Subject: AP1000 Response to Request for Additional Information (SRP 3)

RAI-SRP3.7.1-SEB1-04 R3

AP1000 TECHNICAL REPORT REVIEW

RAI Response Number: RAI-SRP3.7.1-SEB1-04
Revision: 3

Figure RAI-SRP3.7.1-SEB1-04-1 – X Seismic Response Spectra on Steel Containment Vessel at Elevation 224'

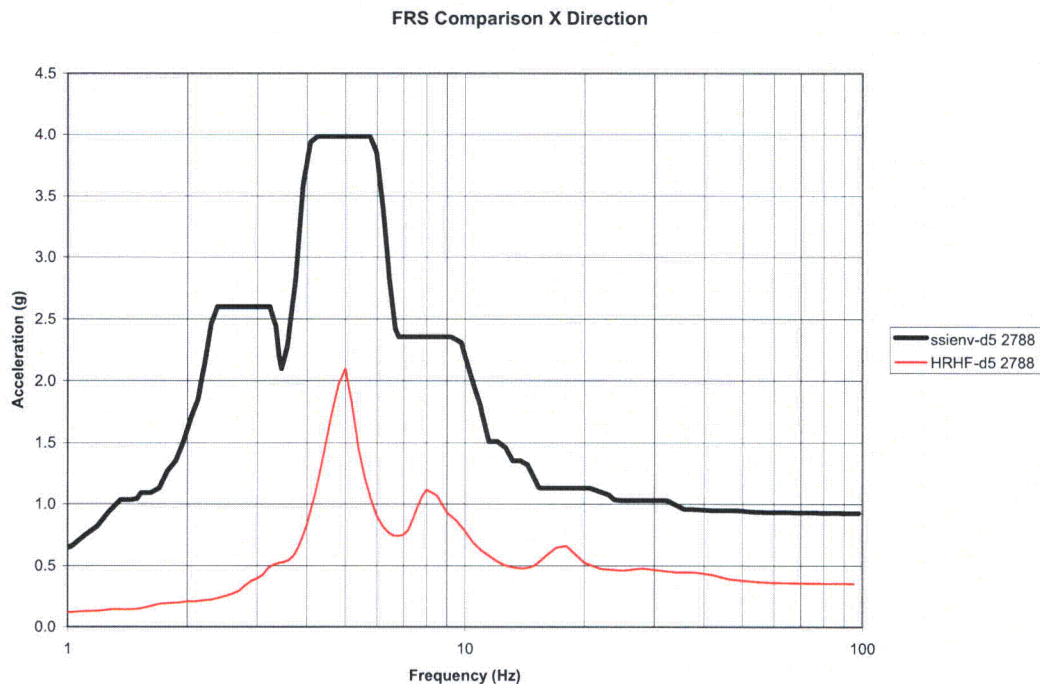
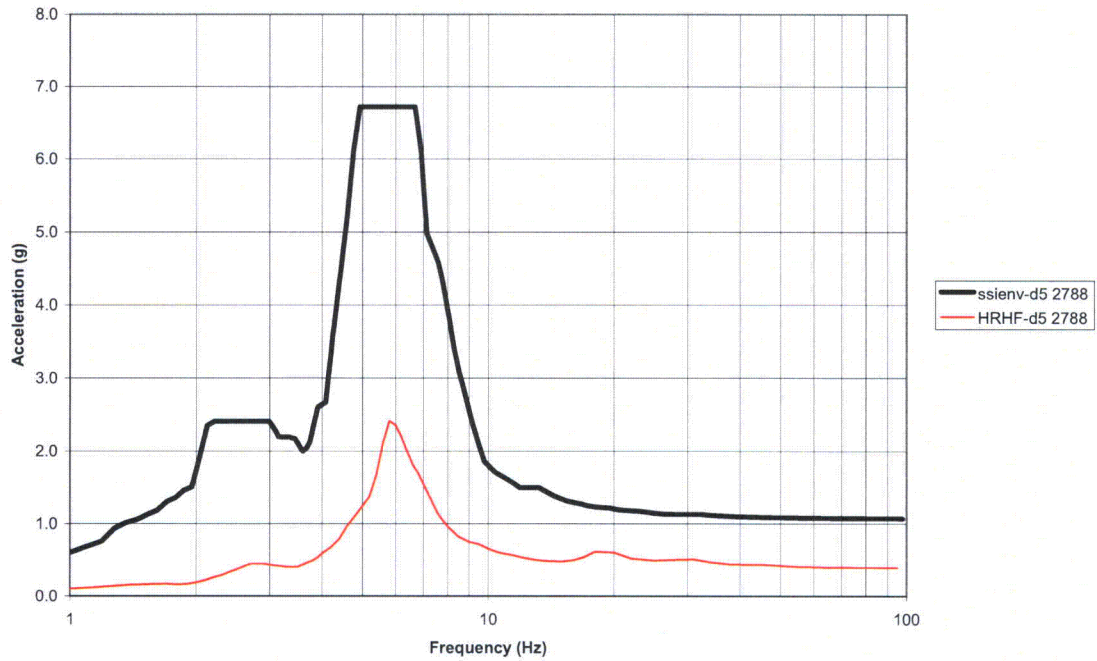
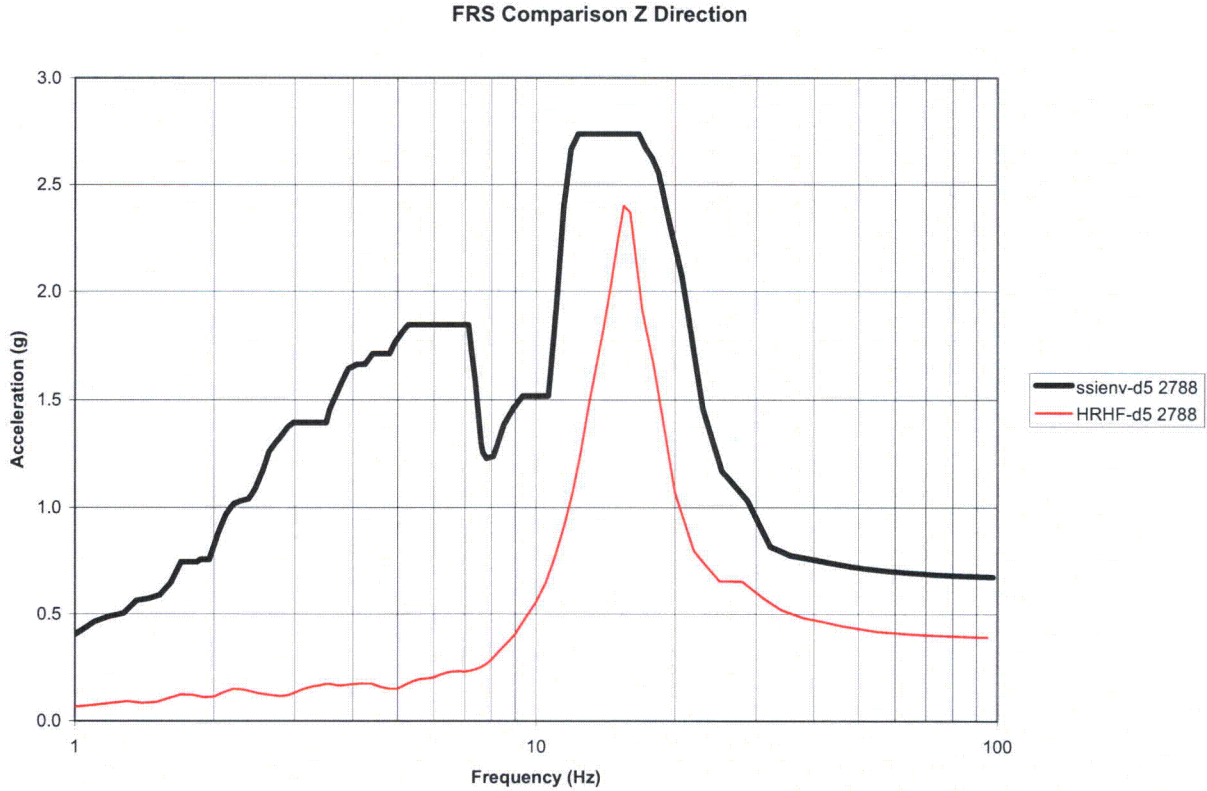
Based on information in DCD Rev. 16, Section 3G.2.1.3, in the discussion of the containment stick model response vs. the containment shell model response, Westinghouse identifies modes in the upper closure dome in the 23 to 30 Hz range. In addition, the modal properties of the attached water weirs and the air baffle attachments are identified to be in the same frequency range. Westinghouse justified the adequacy of the containment stick model on the basis that these high frequency modes in the containment dome and attachments would NOT be excited by the CSDRS (modified RG 1.60 spectra), because the CSDRS has no energy in this frequency range. While this may be adequate justification for use of a stick model for analysis of the steel containment shell response to the CSDRS, the staff notes that the HRHF GMRS has significant energy in 20-30 Hz frequency range, and would be expected to excite the shell vibration modes in the upper closure dome.

Based in the information reviewed to date, the staff is concerned that Westinghouse did not select an adequate sample of structures locations, for demonstrating that the AP1000 structural responses due to the HRHF GMRS are enveloped by the structural responses due to the CSDRS. Since the upper closure dome of the steel containment shell will be excited by the HRHF GMRS, the staff requests that Westinghouse provide detailed results for the response of the steel containment shell, including the local flexible modes in the upper closure dome, due to seismic excitation by the HRHF GMRS, and compare it to the design-basis CSDRS response, for both a stick model representation and a shell model representation of the steel containment shell.

The seismic response spectra in the vicinity of the polar crane (~224' elevation) is representative of the seismic response that the upper closure dome and the attached water weirs and air baffle attachments will experience. These floor response spectra (5% damping) are shown in Figures RAI-SRP3.7.1-SEB1-04-1 to RAI-SRP3.7.1-SEB1-04-3. As seen from these spectra comparisons, the CSDRS floor response spectra identified as SSIENV envelop the HRHF floor response spectra. Therefore, it can be stated that the items identified (upper closure dome, water weirs and the air baffle attachments) will have lower response due to HRHF response than that obtained from the CSDRS excitation.

It is true that the upper closure dome is in the 23 to 30 Hz range. However, as seen in Figures RAI-SRP3.7.1-SEB1-04-1 to RAI-SRP3.7.1-SEB1-04-3 the dominant frequency is below 10 hertz for the horizontal directions, and below 20 hertz in the vertical direction. The high frequency motion will be filtered, and there will be no significant energy to excite the higher modes in the 23 to 30 hertz range. The filtering of the high frequency motion is seen in the RAI figures. Westinghouse has selected an adequate sample of structural locations for demonstrating that the AP1000 structural responses due to the HRHF GMRS are enveloped by the structural responses due to the CSDRS.

Figure RAI-SRP3.7.1-SEB1-04 - Vertical Mode No. 3 (mode 5 from the analysis, 24.2 Hz)

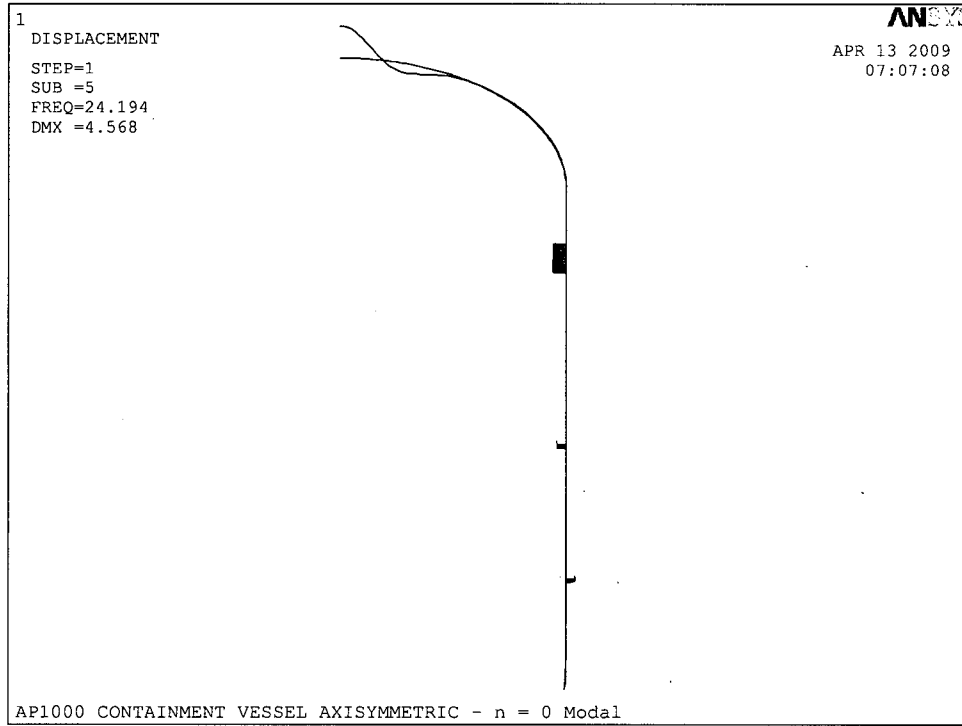
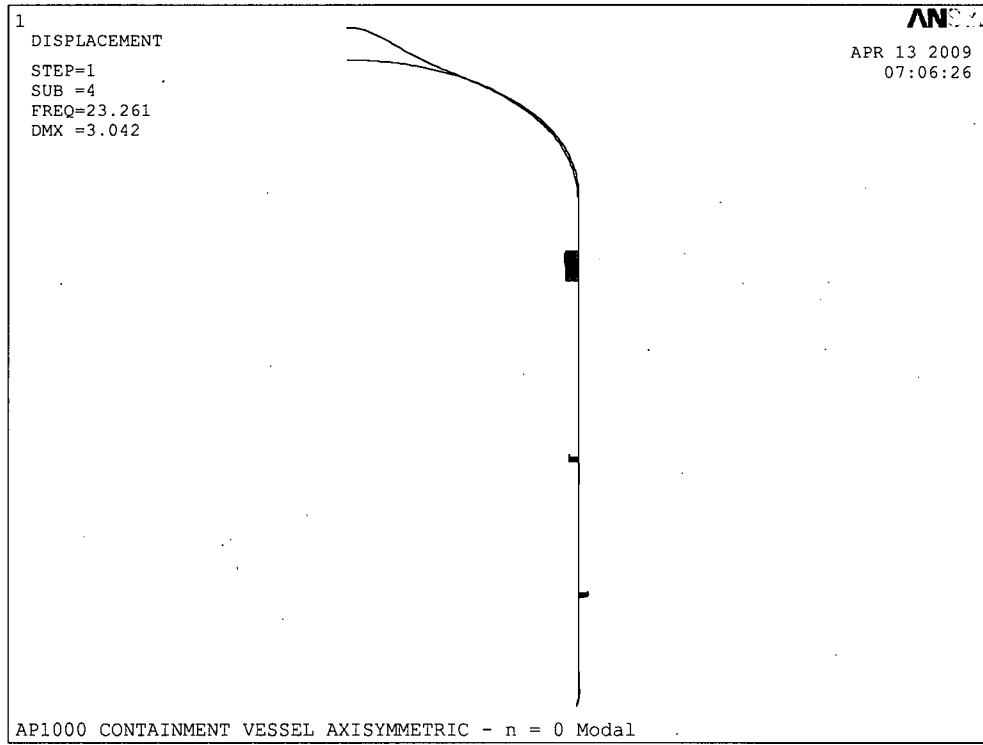
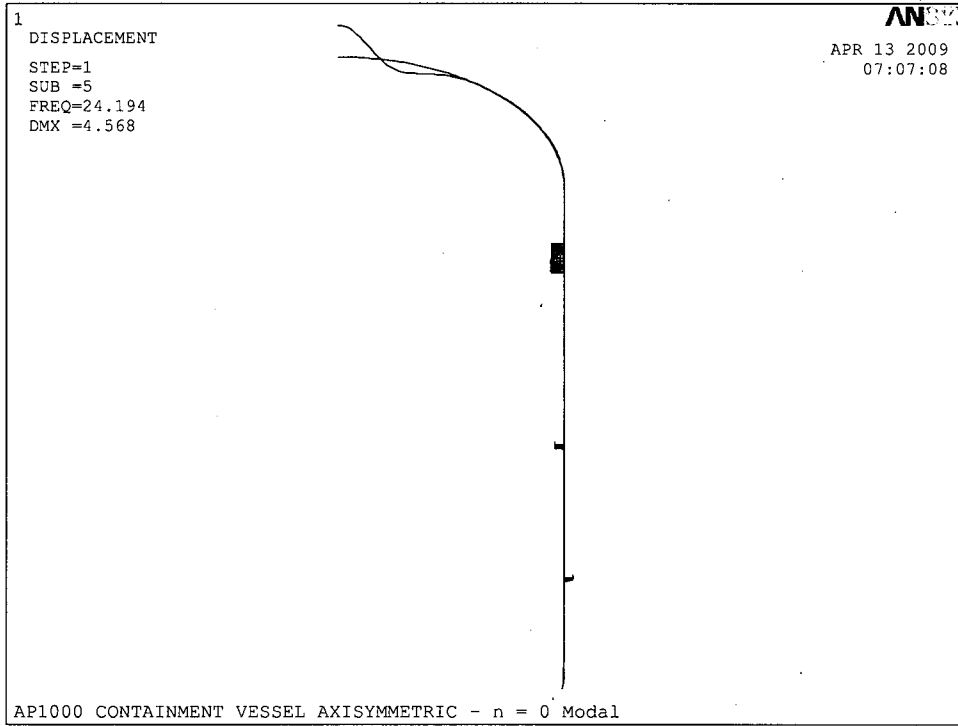
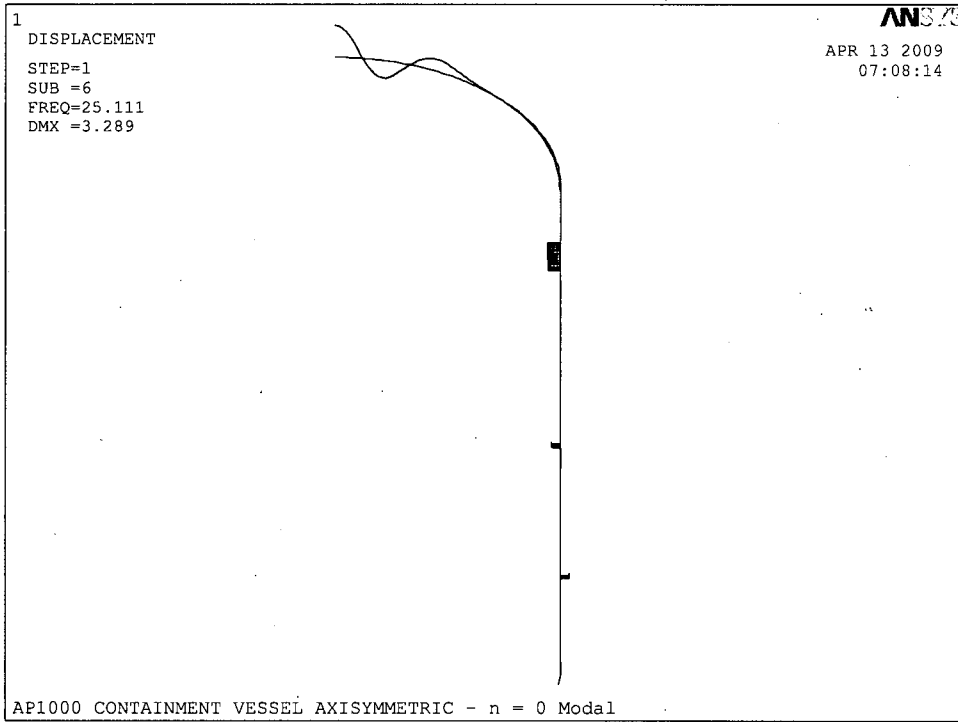
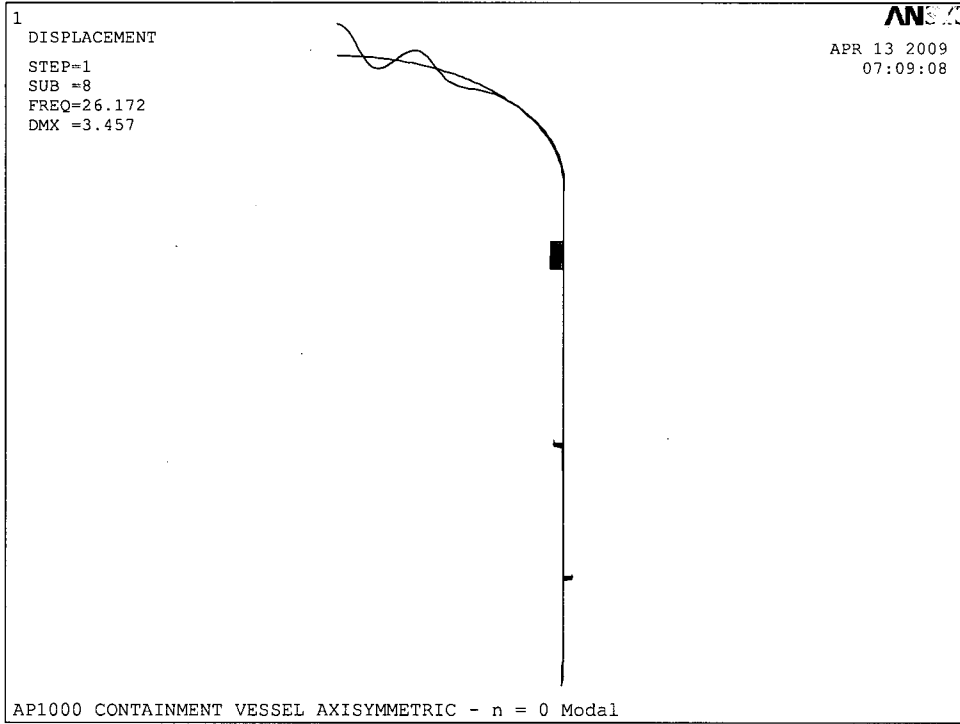
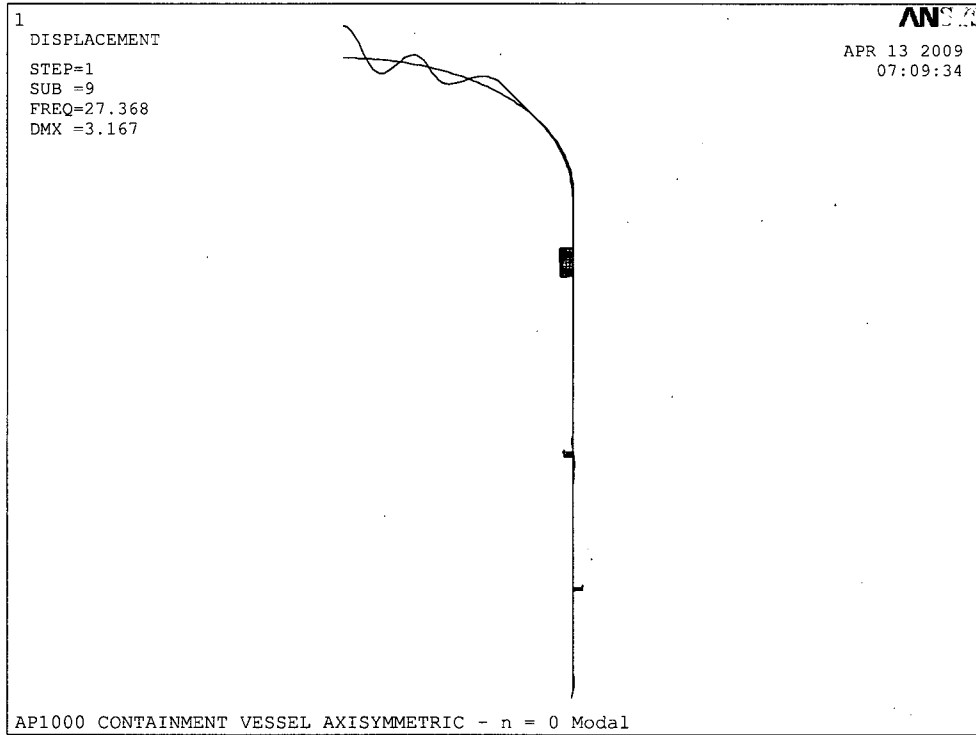
The shell vibration modes of the steel containment shell, including the local modes of the upper head, which could potentially be excited by the HRHF input, need to be audited. The CSDRS spectra and the HRHF spectra at the base of the containment shell need to be audited, to assess why the CSDRS spectra envelope the HRHF spectra over the entire frequency range of interest, in conjunction with the assessment in (1) above. The results of response spectrum analysis of the containment shell model, for both the CSDRS spectra and the HRHF spectra,

In Figure RAI-SRP3.7.1-SEB1-4 to RAI-SRP3.7.1-SEB1-04-9 are shown the vertical modes obtained from the axisymmetric model. A comparison of the frequencies and effective mass for the modes from the axisymmetric and stick model is given in Table RAI-SRP3.7.1-SEB1-1. As seen from this table the dynamic behavior of the stick and axisymmetric models are the same. The stick model can be used in the combined nuclear island seismic analyses.

Figure RAI-SRP3.7.1-SEB1-11 – Stress Intensity comparisons, Middle Layer

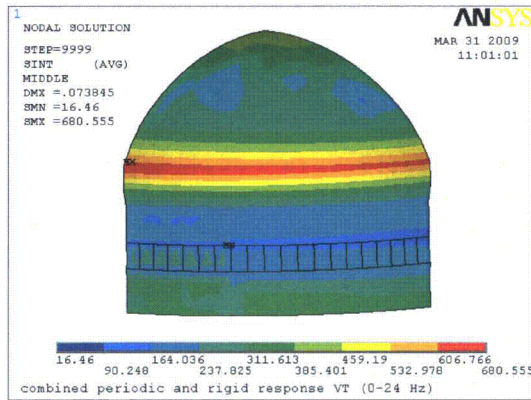
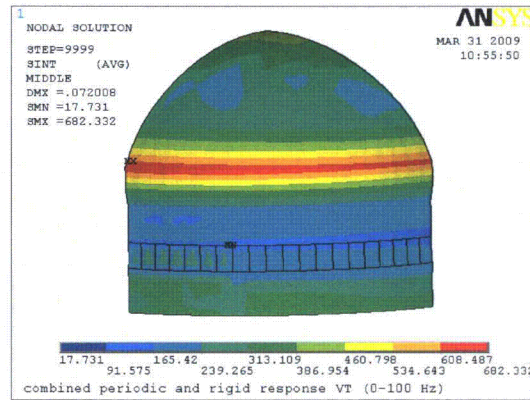
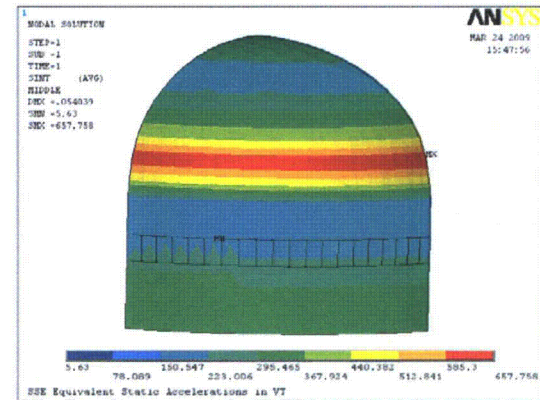
needs to be audited, for possible impact on the containment shell stress evaluation to ASME Code Section III, Subsection NE requirements. Please document the results that were audited during the audit performed the week of April 12, 2009.

The results were compared against an equivalent static analysis. The results are shown in Figures RAI-SRP3.7.1-SEB1-04-11 and RAI-SRP3.7.1-SEB1-04-12. It was found that the equivalent static analysis middle layer results were within 4% OF THE RSA 0-50 Hz analysis, and the equivalent static analysis top and bottom results within 3% of the RSA 0-50 Hz analysis. It is concluded that:

Stress Intensity, Middle Layer, Equivalent Static within 4% of RSA 0-50Hz
